Design Review

2301 West Newton Street

3008430/ 3008429

Design Review Board Comments and Team Responses

ECA EXEMPTION

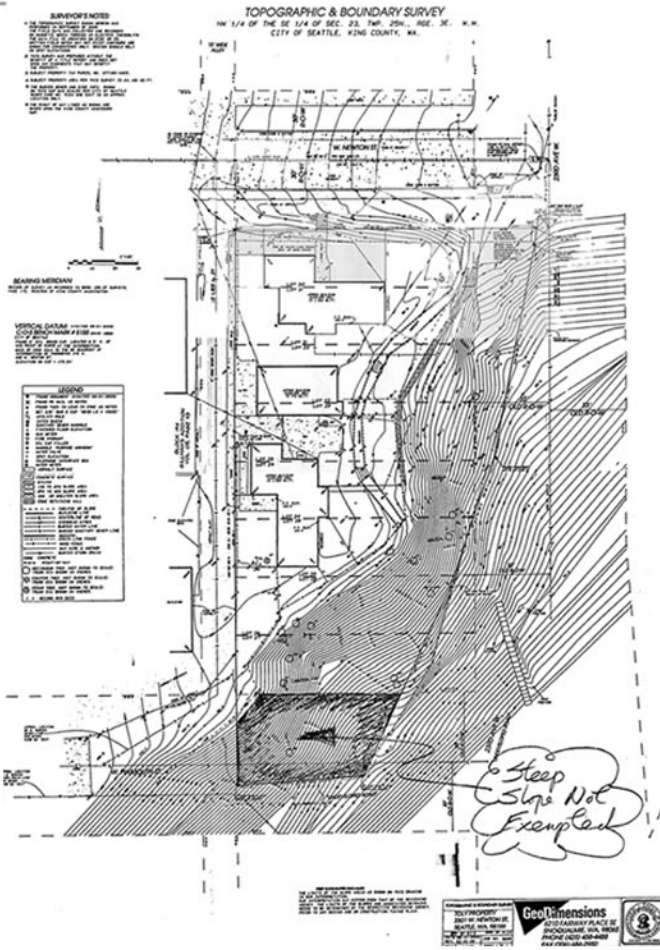
- Based on the submitted 1935 topography, the existing property (Lots 20 thru 27, inclusively) does not appear to contain any ECA 'steep slope' areas as defined in 25.09.020. In this respect, the 'steep slope areas' at these lots are inferred to have been created by previous legal grading and/or construction activities at the aforementioned lots. Further, the submitted updated report by Geotech Consultants, Inc. had implied that granting this exemption will not result in adverse impacts at this site and adjacent properties. In this respect, the ECA Steep Slope Development Standards (i.e. requirements for a Steep Slope Area Variance) are waived for the development associated with DPD Application No. 6163271 at Lots 20 thru 27, inclusively. All other ECA Submittal, General, and Landslide-Hazard, and development standards will apply for this project. **The subject site is also designated as a Potential Landslide Area due to Geologic Conditions and all future permit applications will require ECA Reviews.**

Further, based on the submitted Site Plan, the proposed development appeared to be located in close proximity to and/or within critical root zone of existing trees located at the subject site. The project arborists shall evaluate and provide mitigations to ensure minimal adverse impacts of the proposed development on the existing trees.

- Based on the submitted 1911 Street Profile for West Plymouth Street, 'steep slope' areas appears to be in existence south of Lot 27 prior to any development in and adjacent to this public right of way. Thus, the request under ECA 25.09.180.B.2.b, 'development is located on steep slope areas that have been created through previous legal grading activities, including rockeries or retaining walls resulting from rights of way improvements, if no adverse impact on the steep slope will result' may not be granted south of Lot 27 within the West Plymouth Street right of way. Please see Attachment B to note the 'steep slope areas' that are not exempted.

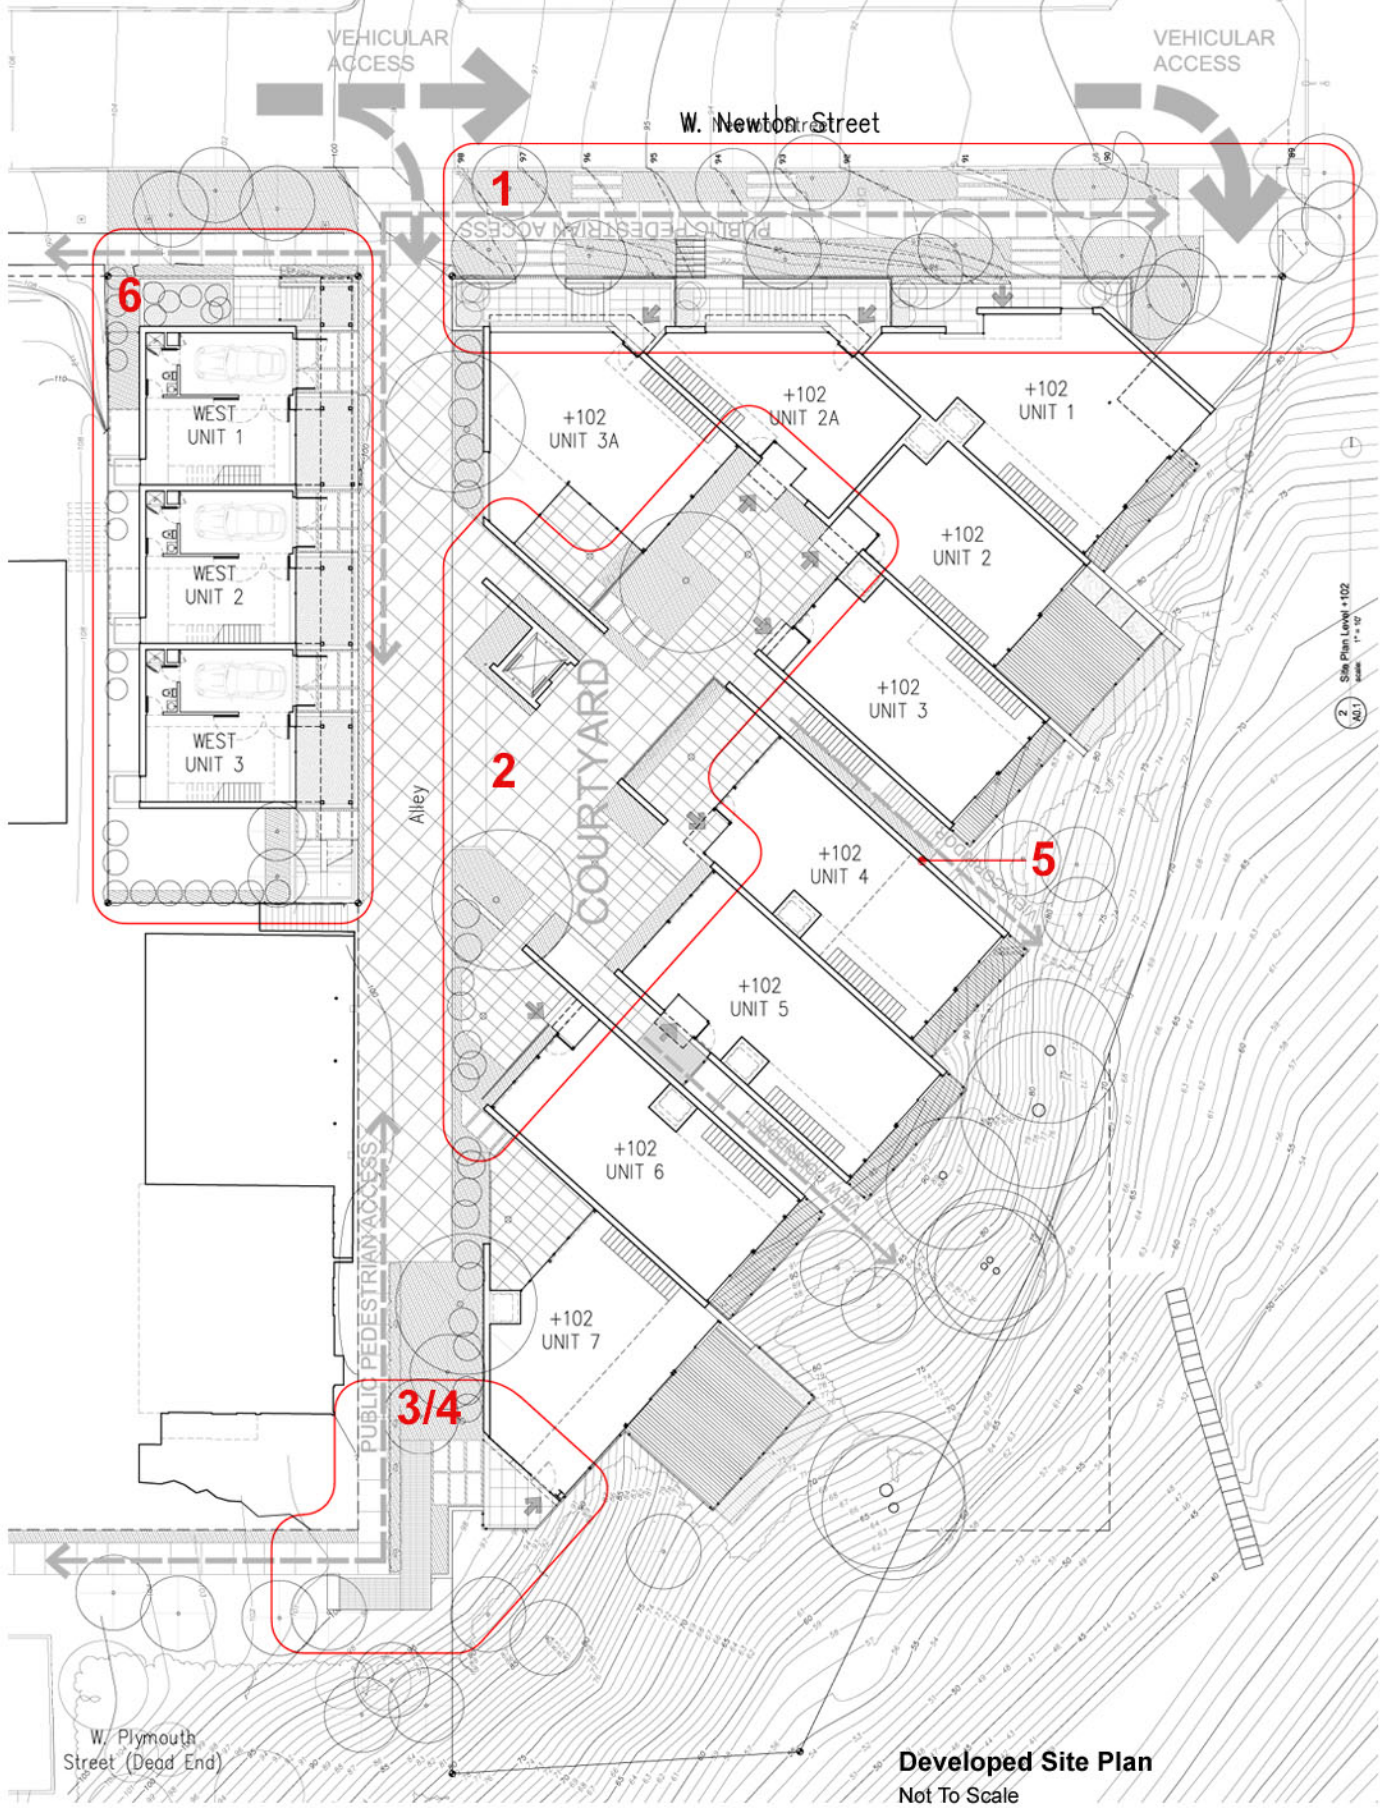
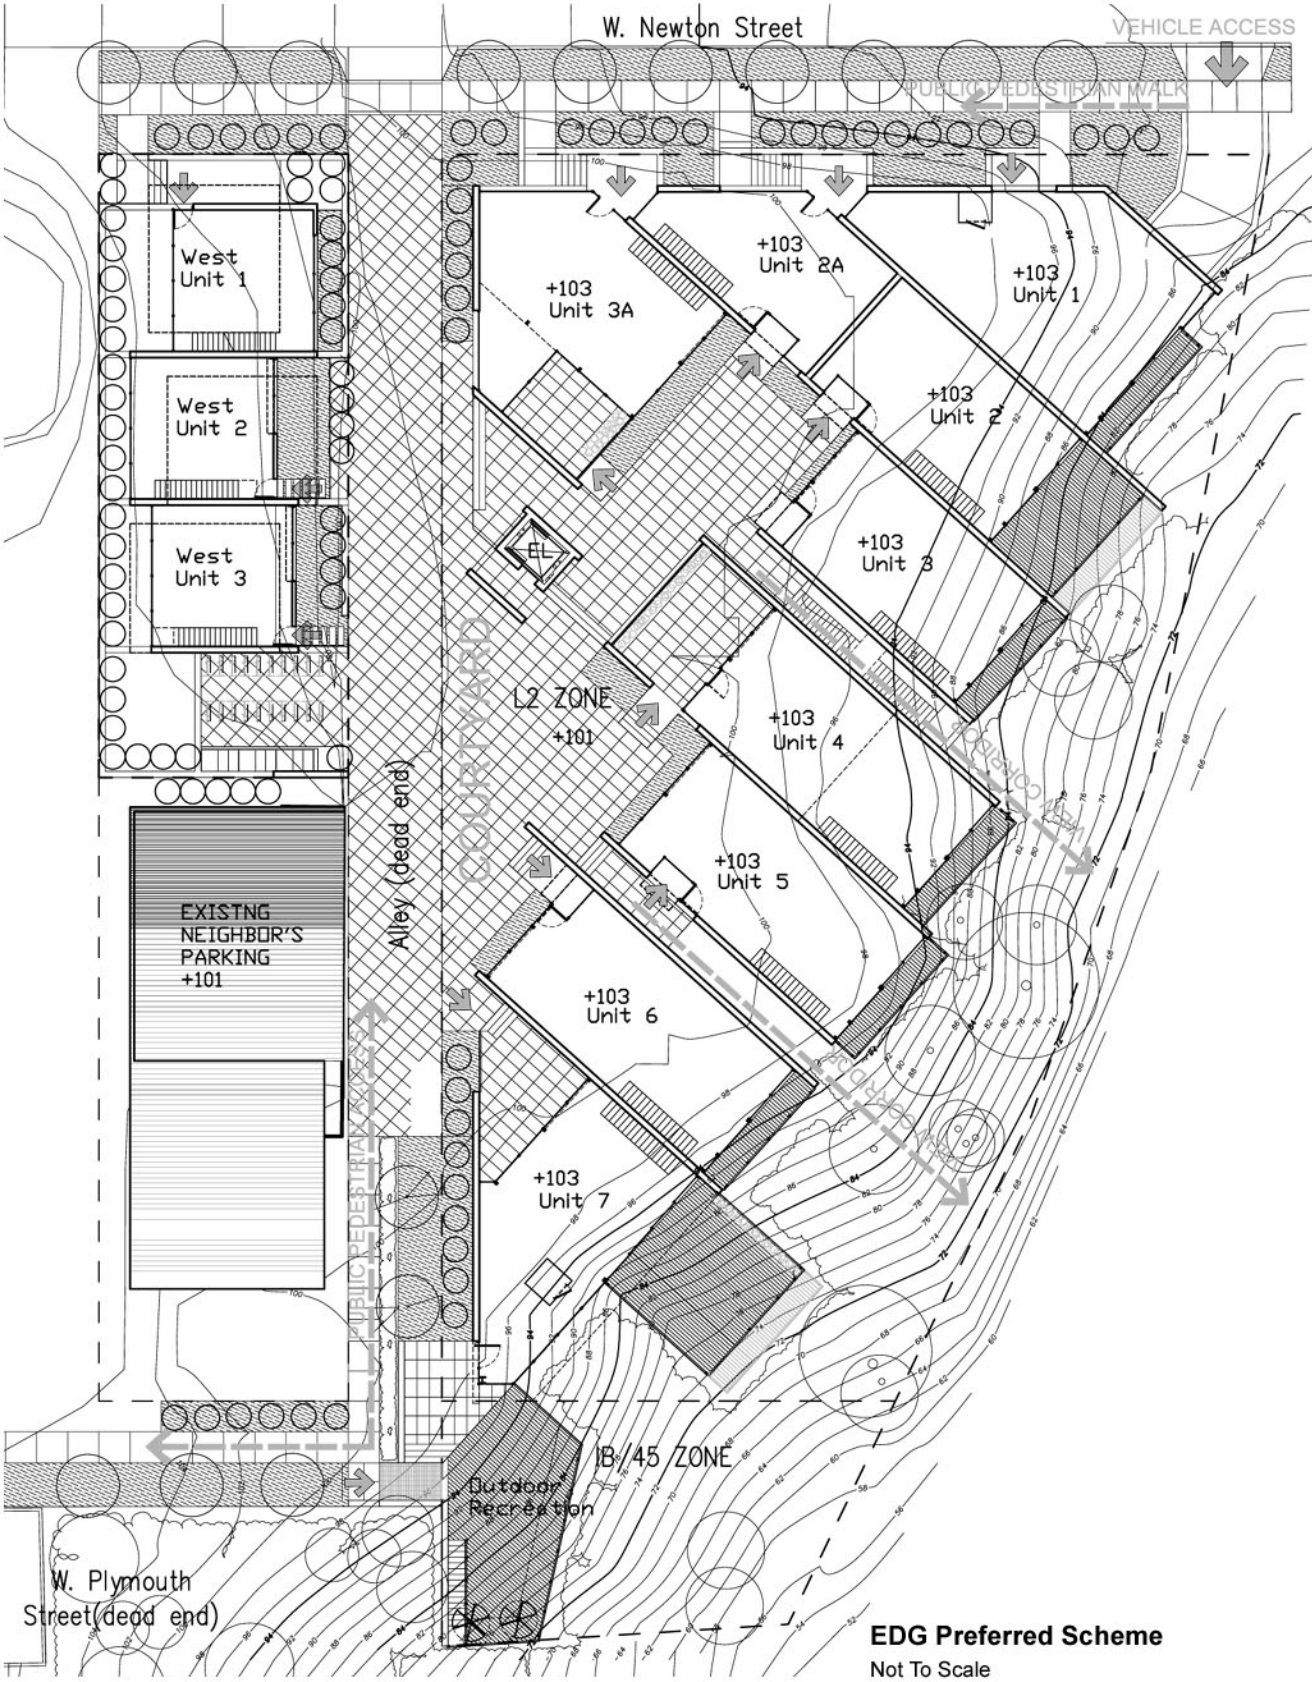
Development of the Courtyard
The Board questioned the location of the elevator tower shown in the center of the proposed courtyard. They feel that it creates a monolithic structure, breaks up the courtyard and reduces the usability of the space. They would like to see the elevator structure relocated to the side of the courtyard.

A landscape plan with plantings called out should be developed that will soften the effects of the hard concrete edges.

- **Elevator Location and Courtyard Configuration.** The elevator has been reposition to align with the edge of the courtyard and the sides of the elevator have been developed as an extension of the series of walls that create the townhouse units and defined the edges of the courtyard.
- **Landscaping.** Landscaping has been developed and includes a series of large trees that are positioned at the edges of the the courtyard and alley. These large trees provide a canopy for shading and the upper branches provide screening for windows on the upper levels of the units around the courtyard. The landscaping of the courtyard and alley has also been developed with concrete pavers, concrete scoring patterns, bar grating screens with vine planting, and under story grasses.
- 3

Street Elevation

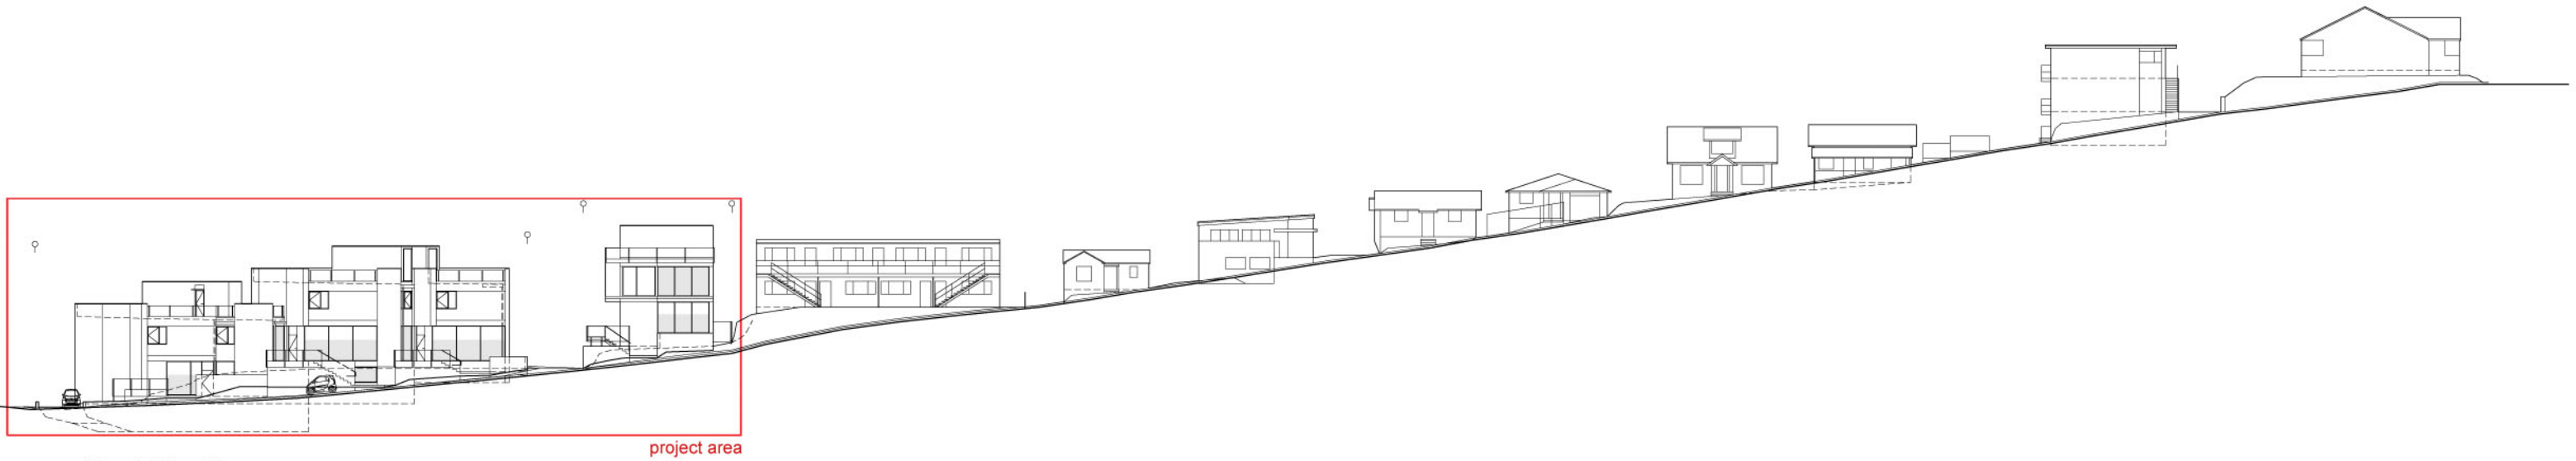
West Newtons Streetscape Development
The Board is willing to consider the front setback departures depending on how well the units facing he right-of-way relate to the street. They look forward to seeing detailed drawings (including stoops, terraces, and landscaping) of how the units enhance the right-of-way and the public realm.

The Board is looking forward to a detailed landscape design that will soften the hard appearance of the concrete surfaces and present an active facade to West Newton.

- **Setback and Modulation.** Two thirds of the West Newton Street Elevation has been stepped back an additional three feet.
- **Stoops and Terraces.** The unit entrances along West Newton have been developed with generous stoops and terraces to create opportunities for personalization and structured buffering between public and private realms.
- **Materials.** The stoops, unit entrances and unit facades have been developed with expressed precast concrete, natural finish wood siding, clear anodized aluminum window systems, canopies, and screening.
- **Landscaping.** The landscaping along the West Newton Street has been developed with layers of native/ drought resistant paint-ings which include street trees, grasses and shrubs.
- 2
